Access Compliance Report

Public Rights-of-Way

(Curb Ramps)

Intersection ID: 13156	Main Street: S_TRYON_ST	Cross Street: W_CARSON_BV	Location: SE
ADA ID: 7726DFCB4588	Ramp Type: Perp	Initial Pass/Fail: Fail	Overall Compliance: No
Severity Score: 12.5			
Codes/Mitigation Info/Possible Solution		Field Measurements/Component Compliance

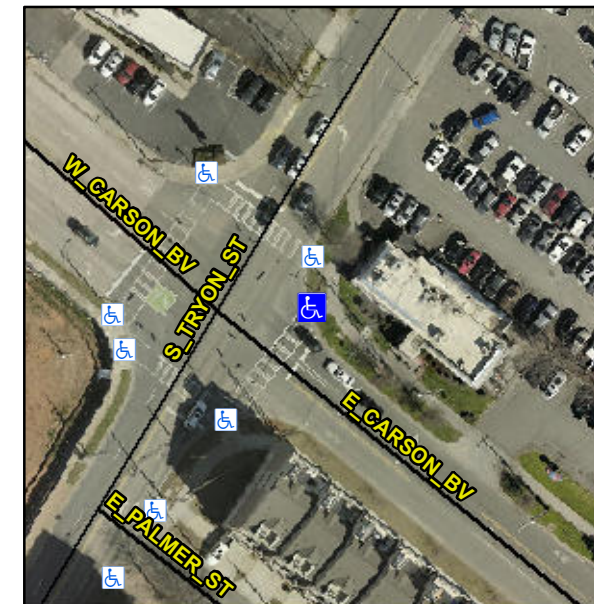
Not Found, R304.2.2

Compliance	Description	Data	Compliance	Description	Data
N/A	Ramp Length (in)	124.0	No	Ramp Slope (%)	9.0
Yes	Ramp Width (in)	74.0	Yes	Ramp XSlope (%)	1.4
N/A	Flare Type LT	N/A	N/A	Flare Type RT	N/A
N/A	Flare Slope LT (%)	N/A	N/A	Flare Slope RT (%)	N/A
N/A	Flare Traversable LT?	N/A	N/A	Flare Traversable RT?	N/A
N/A	Landing Length (in)	N/A	N/A	DWS Provided?	N/A
N/A	Landing Width (in)	N/A	N/A	DWS Contrast?	N/A
N/A	Landing Slope (%)	N/A	N/A	DWS Length (in)	N/A
N/A	Landing X Slope (%)	N/A	N/A	DWS Full Width?	N/A
N/A	Landing Curb? (Y/N)	N/A	N/A	DWS Offset (in)	N/A
N/A	Shared Landing?	N/A			
N/A	Gutter Ponding?	N/A	N/A	Gutter Slope (%)	N/A
N/A	Gutter Lip Ht (in)	N/A	N/A	Gutter X Slope (%)	N/A
N/A	Painted X Walk1?	Yes	N/A	Painted X Walk2?	N/A
	X Walk 1 Direction	To SW		X Walk 2 Direction	N/A
N/A	X Walk 1 Width (in)	112.0	N/A	X Walk 2 Width (in)	N/A
	X Walk 1 Slope (%)	4.2		X Walk 2 Slope (%)	N/A
	X Walk 1 X Slope (%)	2.1		X Walk 2 X Slope (%)	N/A

Remove & Replace Entire Ramp.
